# **Port Ellen Terminal Development**

Environmental Impact Assessment Report  
Addendum

February 2026

**Document reference:** 115031-MMD-PE-XX-RP-O-0024

**Figure 6-1: Spatial current flow around Port Ellen and the new disposal ground for the calibration period during neap tide showing flood tide (right) and ebb tide (left)**

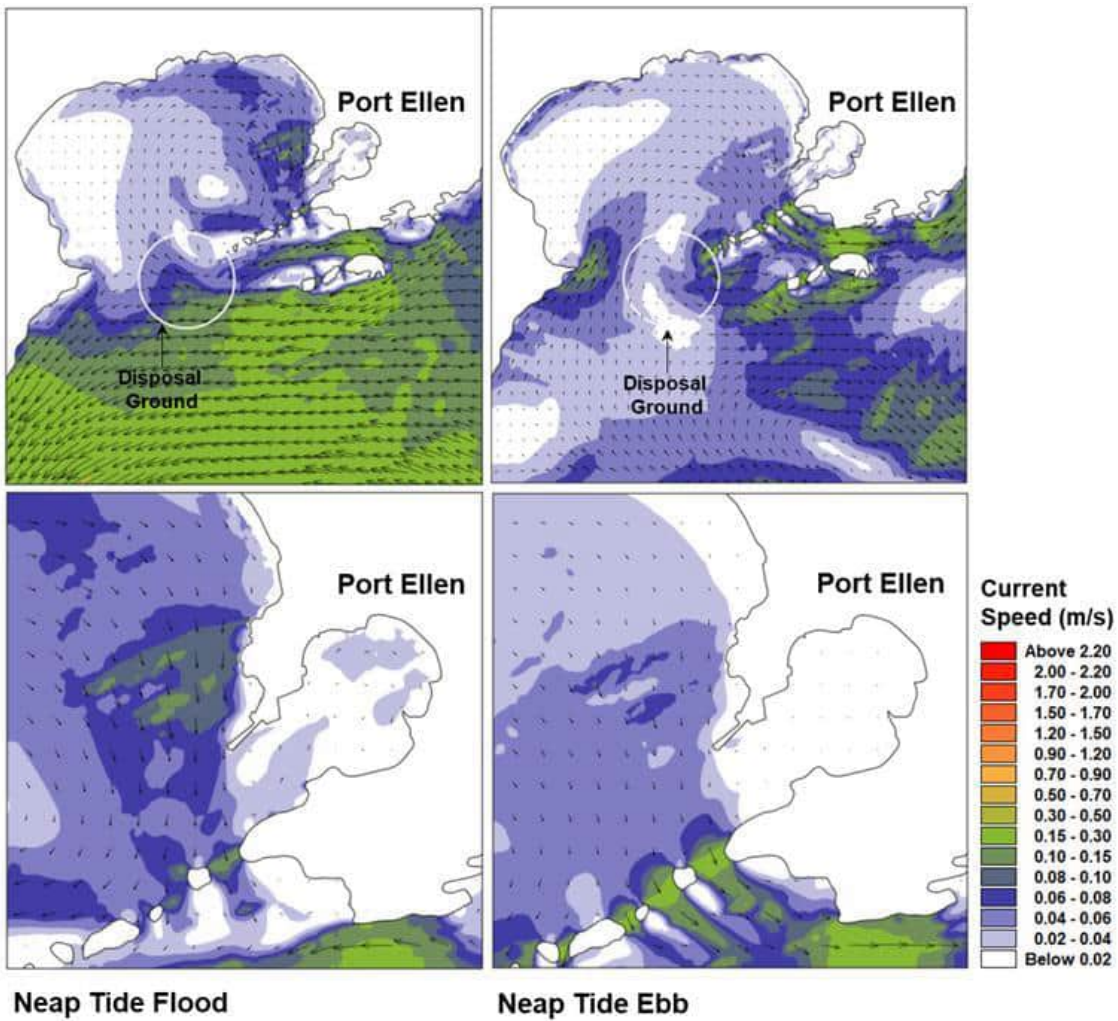
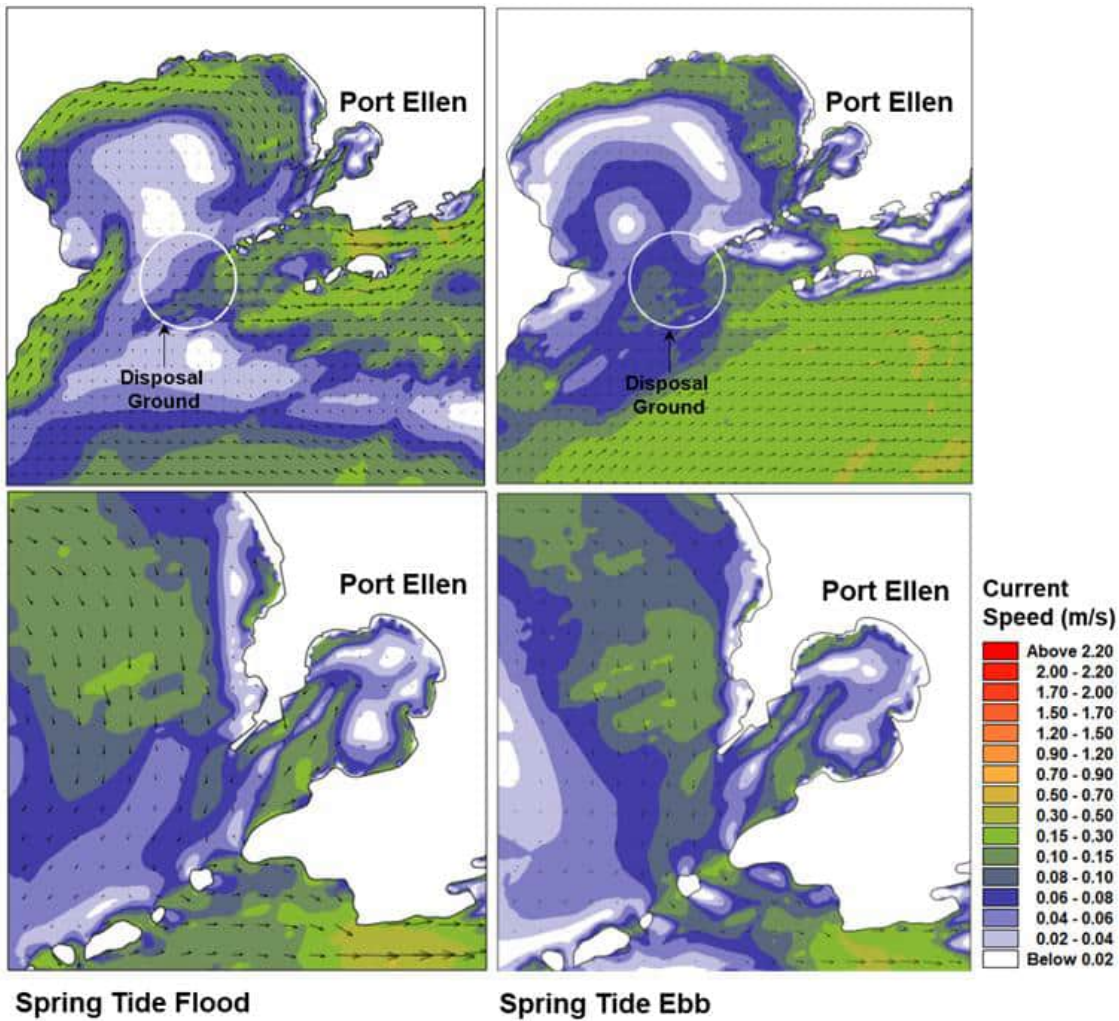
The update in proposed disposal location will result in a change to the tidal regime that will affect SSC from disposal activities. The tidal flows at the previously agreed disposal ground were relatively strong and directed northwest during the flood tide and to the southeast during the ebb tide. Additionally, interactions between the strong offshore flow and weaker flows within the shallow bay during the ebb tide would have resulted in eddies near the proposed disposal ground (MA035), increasing sediment dispersion during the disposal process.

As per Figure 6-1 and Figure 6-2, the updated hydrodynamic model outputs show that peak tidal currents in the vicinity of the new disposal ground (MA030) are generally gentle, with markedly lower current speeds than those observed further offshore or within the main channel approaches to Port Ellen. The refined spatial plots of flood and ebb tide conditions under both neap and spring tidal cycles demonstrate a consistent pattern of weak, predominantly tide-driven flow, with only limited local acceleration near constricted parts of the coastline.

Figure 6-3: Water bodies surrounding the proposed development and disposal site

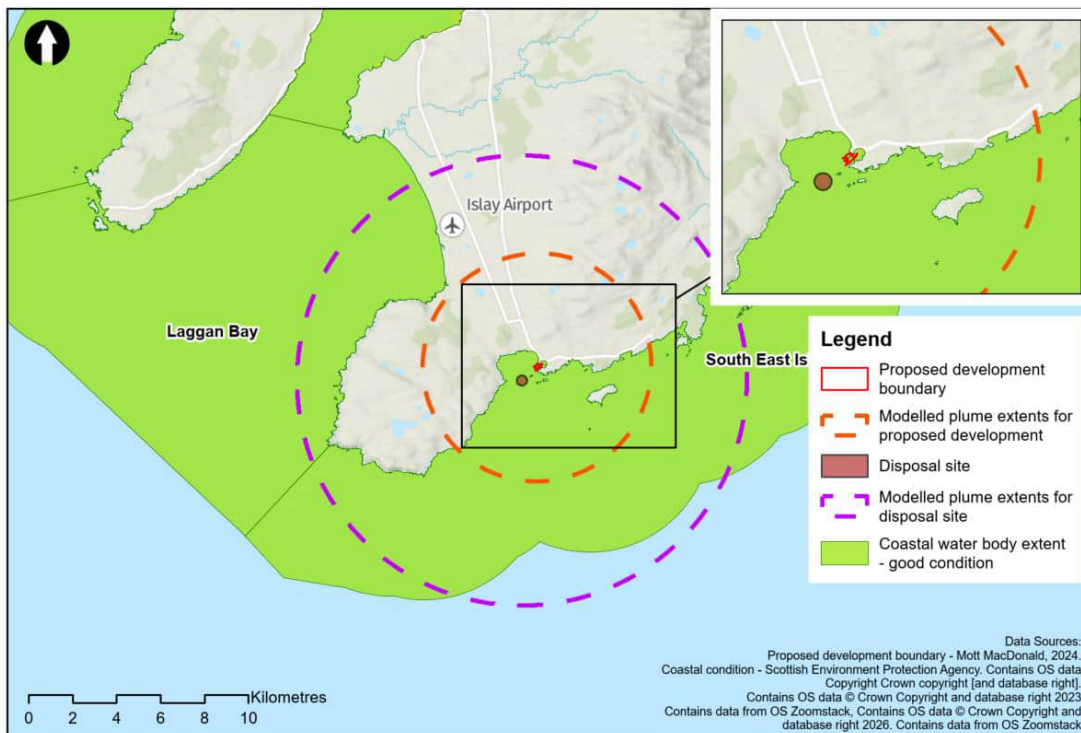
As the disposal site has moved from Laggan Bay coastal water body (SEPA ID 200302) to South East Islay coastal water body (SEPA ID 200304) (Figure 6-3), Laggan Bay coastal water body should be referenced only as a nearby water body. Additionally, water body classifications for Laggan Bay should no longer be considered within the baseline of Volume 2, Chapter 9, Table 9-8 of the EIA report.

**Figure 6-4: Modelled maximum SSC for sediment comprising 70% fines (with wind) (a) within 10 km of Port Ellen, (b) within 1 km of Port Ellen, and (c) around Port Ellen for combined Dredging and Disposal**

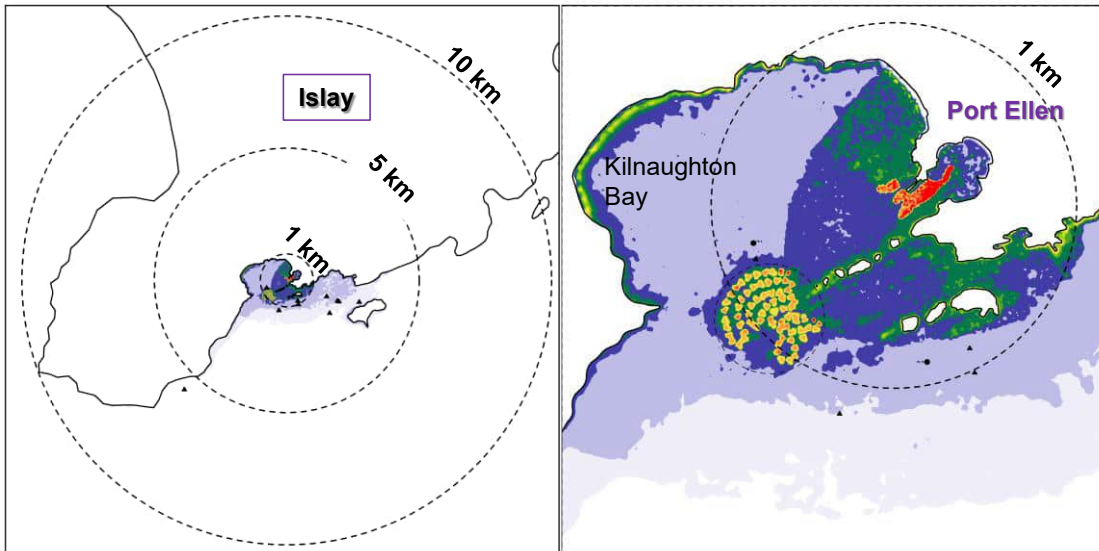
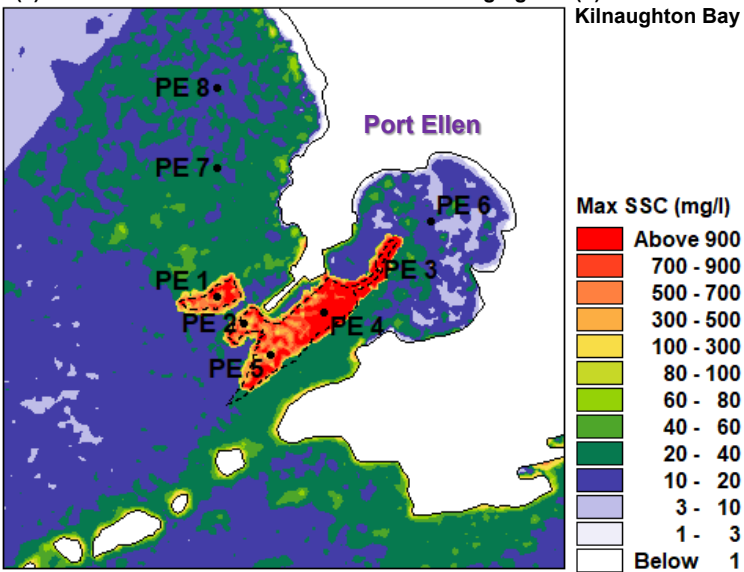
As per Figure 6-4 and Figure 6-5 modelled SSC results for 70% fines and 30% fines under wind-forced conditions show that the highest concentrations occur within the immediate dredge footprint, where the model predicts short-duration peaks exceeding 1,000 mg/l. These values reflect the numerical representation of a point-source release in shallow water, where dilution is artificially constrained; in reality, rapid settling and mixing would occur.

Within the designated disposal area, predicted maximum SSC values exceed 500 mg/l at the moment of release but decrease quickly to <50 mg/l. Across the broader 1 km radius surrounding the disposal ground, SSC maxima range from 20 to 80 mg/l. Around Port Ellen and the island chain, modelled maxima are generally above 40 mg/l, with isolated pockets exceeding 80 mg/l. Further afield—beyond the Port Ellen development area and Kilnaughton Bay—concentrations reduce to 10–20 mg/l, diminishing to negligible levels by approximately 5–10 km from the source.

**Figure 6-6: Modelled sedimentation at the end of dredging for 70% fine fraction and wind**

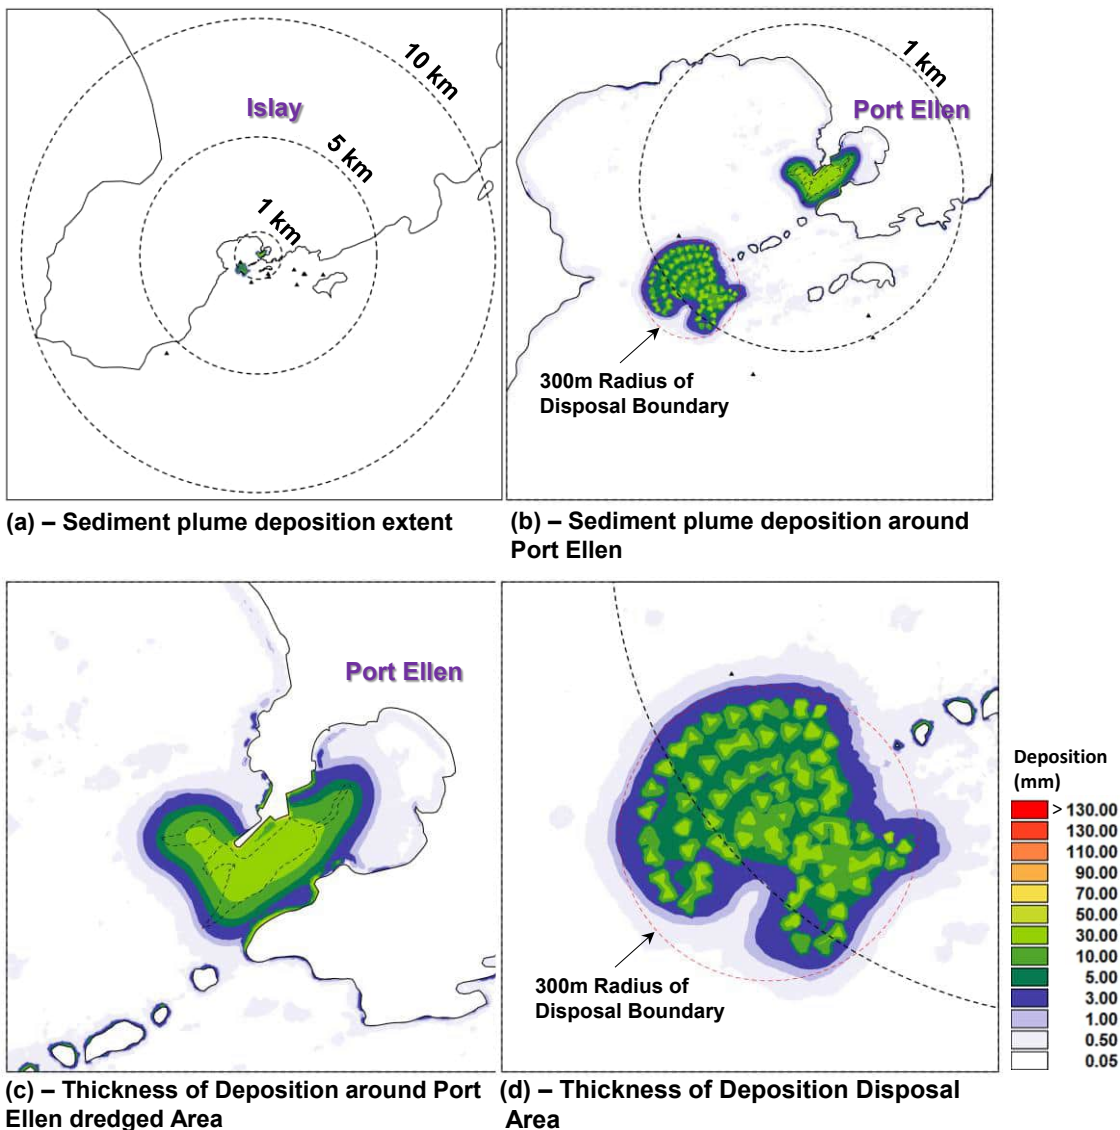
Figure 6-6 (c) and Figure 6-7 (c) illustrate the predicted sediment deposition associated with the dredging operations, based on sediment loss scenarios containing 70% and 30% fines, respectively. The modelling indicates that the deposition associated with dredging remains highly localised, with:

Figure 6-6 (d) and Figure 6-7 (d) illustrates the predicted sediment deposition associated with the dredging operations at the disposal ground. Sediment deposition at MA030 forms a small, well-defined mound, consistent with the low energy hydrodynamic environment:

- Peak deposition thickness reaches 100–130 mm at the mound centre.
- Thickness gradually decreases to 30–50 mm across most of the disposal footprint.
- Deposition is <0.5 mm across wider Port Ellen Bay beyond the 300 m boundary.
- Regional deposition remains <0.05 mm, confirming that the disposal mound is tightly confined and does not contribute to broader morphological change.

**Port Ellen Terminal Development**  
**Figure 7-1**  
**Ecological Designated Sites**

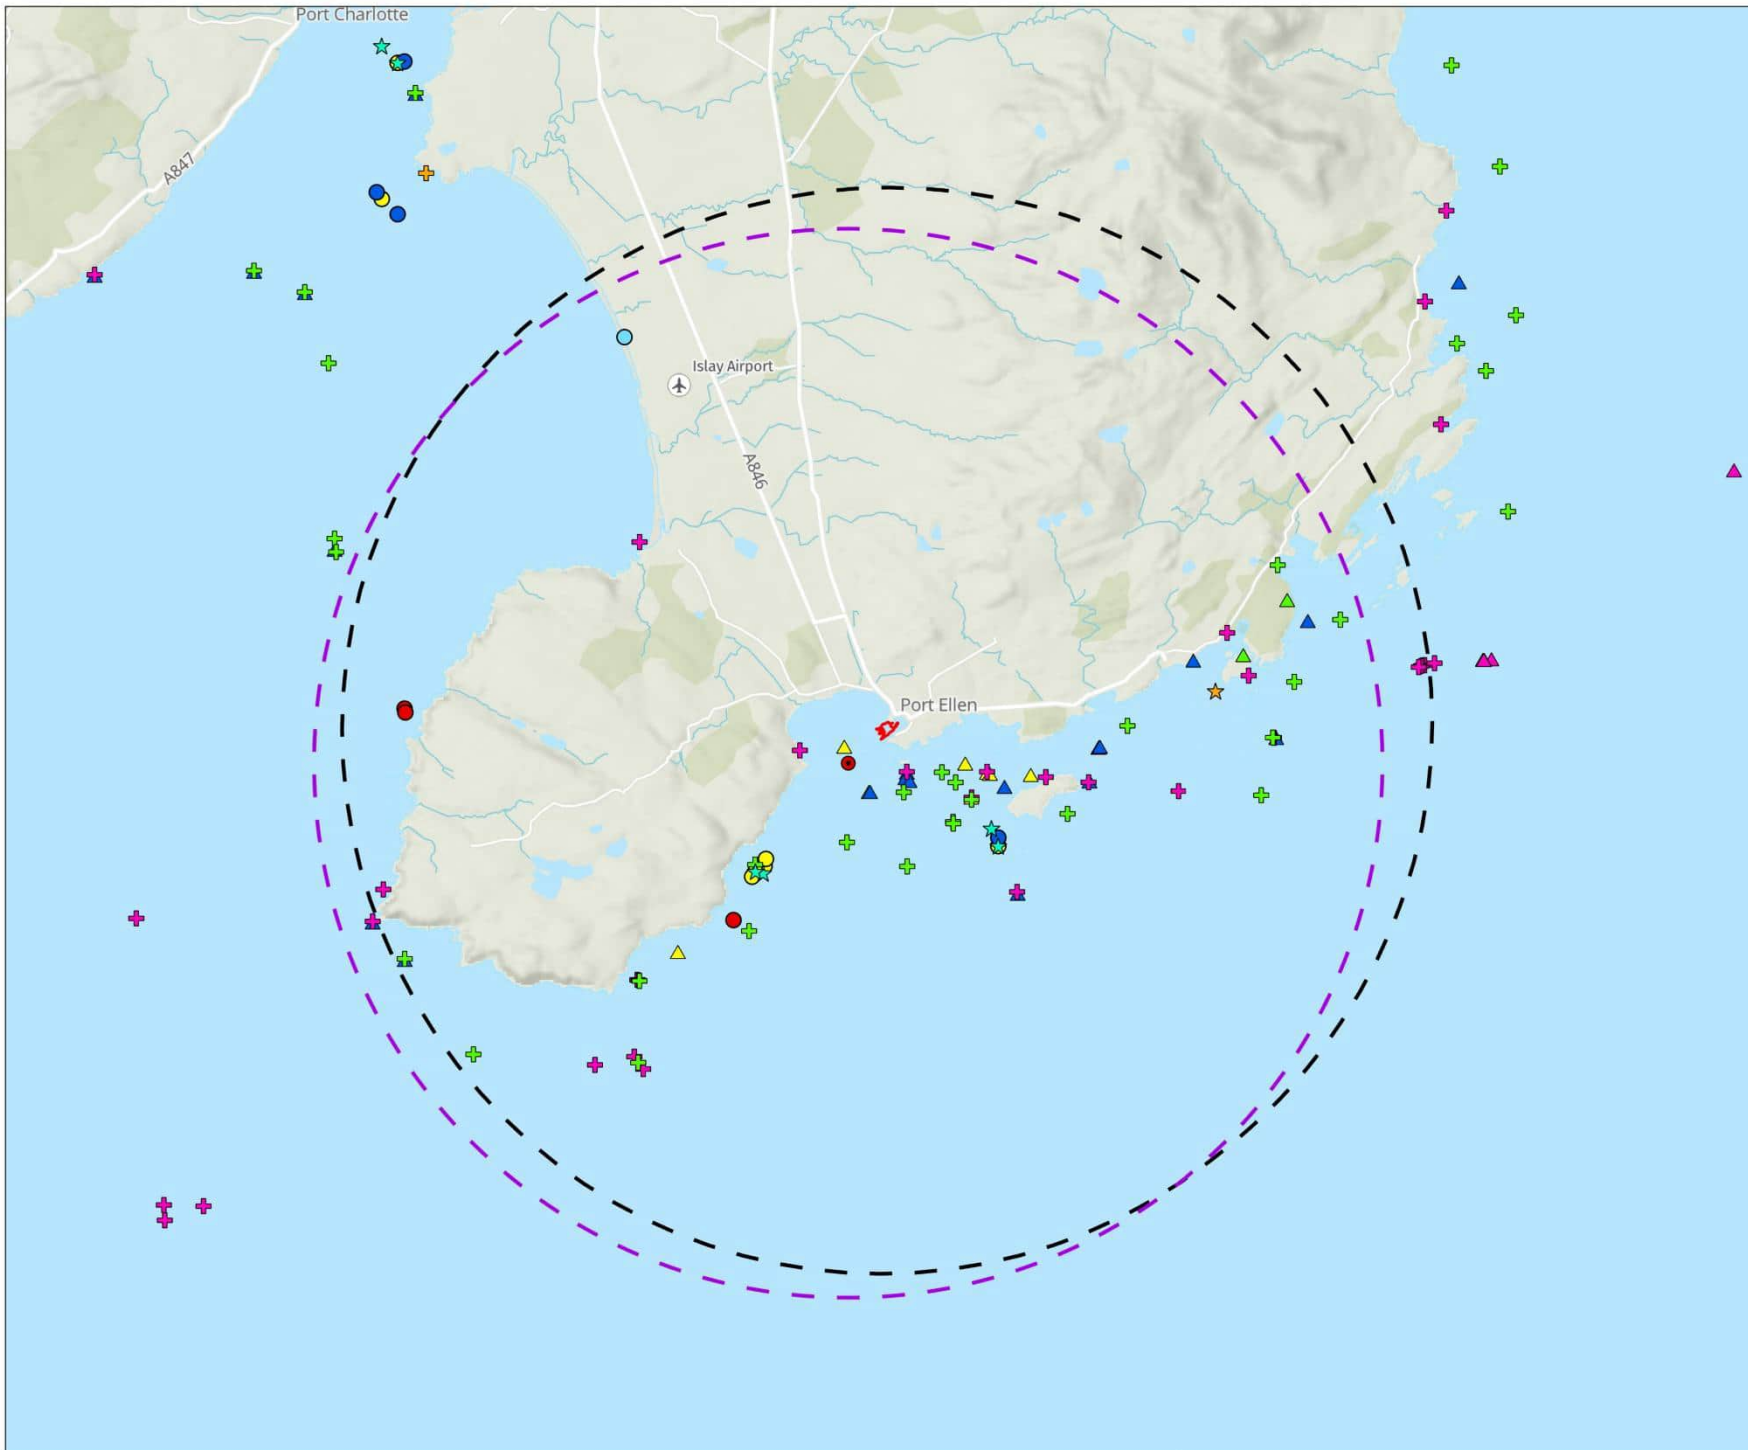
No change to the methodology for determining Zol – See Volume 2, Chapter 7, Ecology of EIA report. The Zol presented in the original Figure 7-1 is changed due to slight adjustment of the Zol from the proposed development taking the disposal site MA030 at the harbour into account, and removal of the Zol associated with the disposal site MA035 as it is no longer considered. The updated Zol is shown in Volume 4, EIA Addendum Figures, Figure 7-1 Ecological Designated Sites.
